HYDROLOGY

RETAINING WALL IN PLACE
SCALE 1" = 80'
FIGURES FROM PREVIOUS REPORT
INTERSTATE HIGHWAY
INDIAN SCHOOL ROAD NE
INDIAN PLAZA DRIVE NE
DRAINAGE SURFACE
BUILD BERM ADJ TO WALK @ 81.8
CONCRETE VALLEY GUTTER
DISCHARGE OF STREET
EXISTING MH
EXISTING DROP INLET (REF CITY DRAWING 66-28-12)
AREA OF OPENING 18" x 26" (3.54 SQ FT)
$Q_{FULL\ RCP} = a\left(\frac{1.486}{n}\right) r^{.67} s^{.50} = 3.14\,(99.06)(.620)(.019) = 62.41$ CFS x Coefficient of Discharge for 30'L x 2'D RCP w/Square cornered entrance
$C_d = .76$
$62.41 \times .76 =$ 46.81 CFS AVAILABLE PIPE CAPACITY
WHERE: a = 3.14
n = .018 (AVG LONG ROUGHNESS)
r = D/4 = .5' (PIPE RUNNING FULL)
s = .0017 FT/FT
REVISED DRAINAGE PLAN
LOS CEDROS APARTMENTS
SHEET 1 OF 2

INTERNAL DRAINAGE PLAN

LOS CEDROS APARTMENTS
ALBUQUERQUE, NEW MEXICO

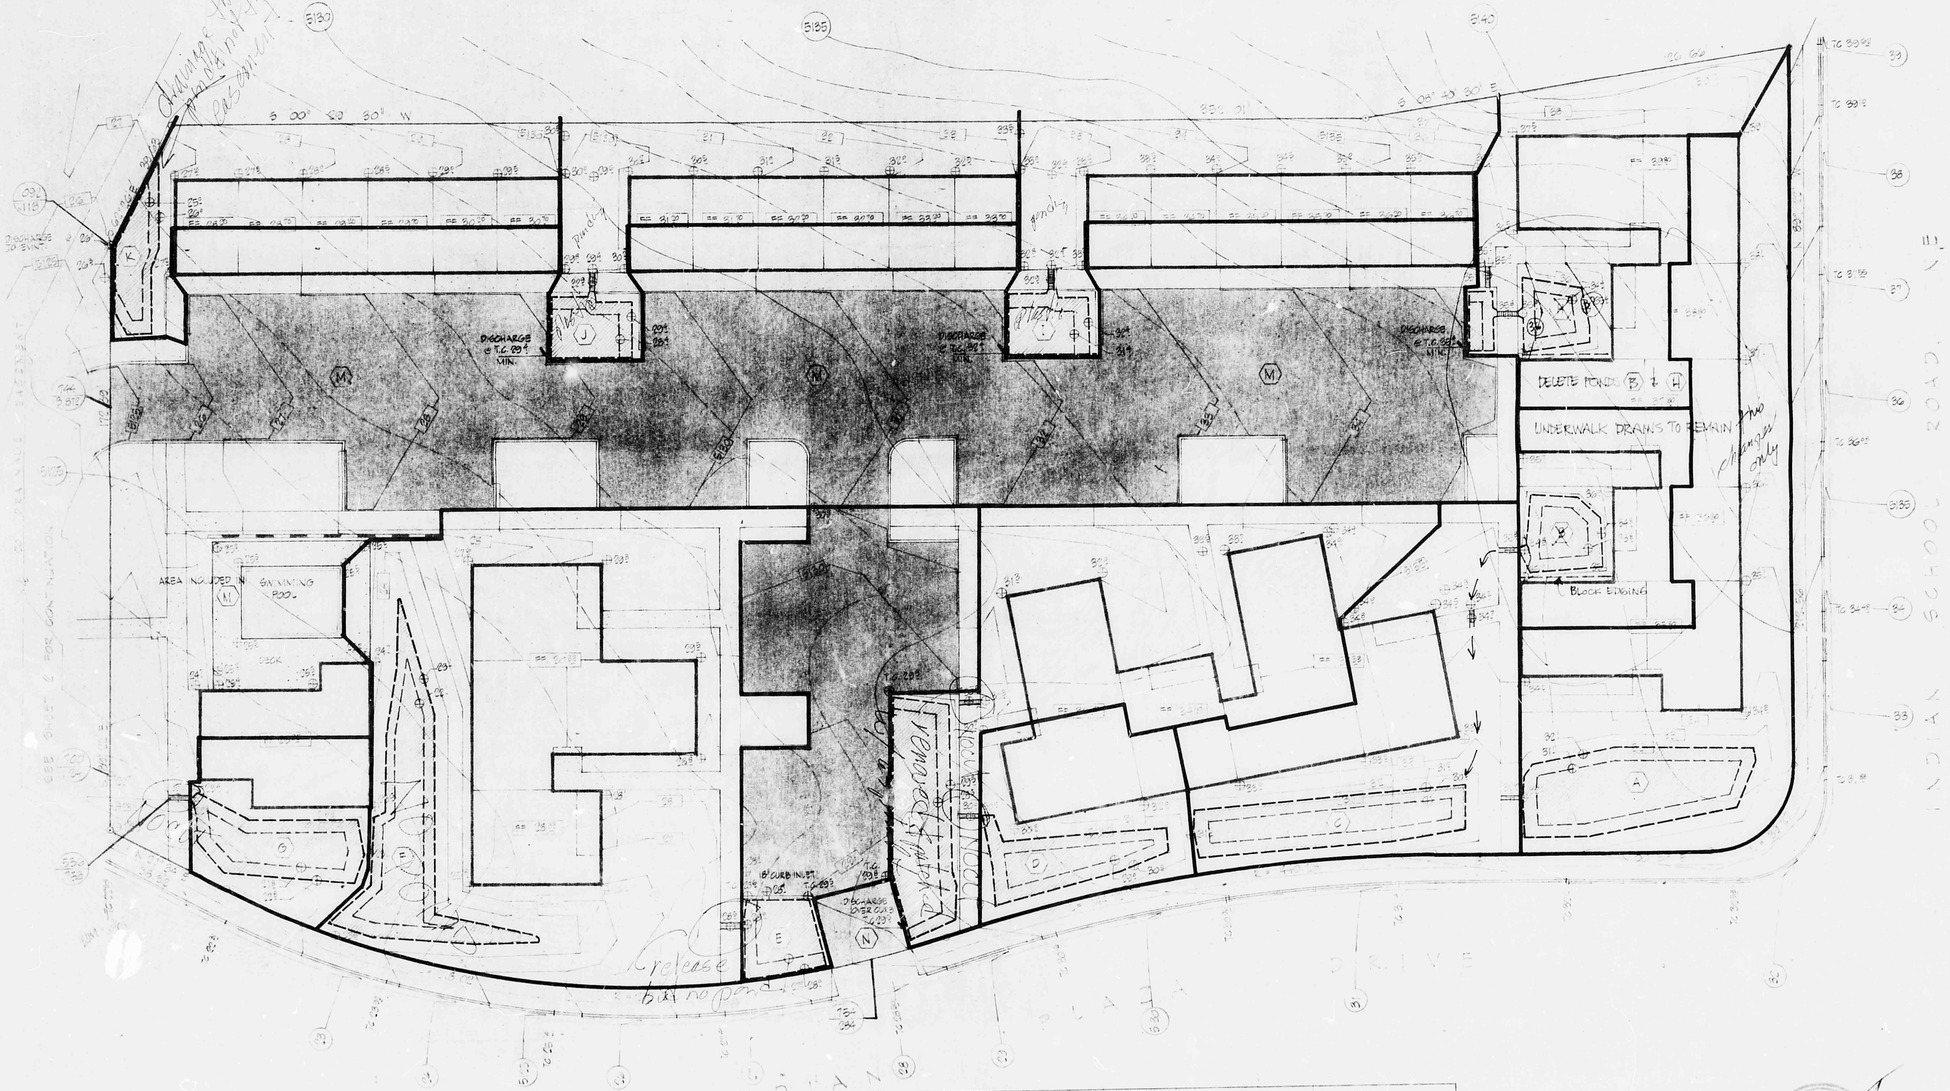
7042 ft³ (> 6936 REQD)

Changes in red
Only changes approved
APPROVED FOR DRAINAGE
4-2-80
Bruce J. Mantyla for Fred J. Sparks
SIGNATURE
ADVISE INSPECTOR OF ANY CHANGES
WITHIN CONSTRUCTION INSPECTOR
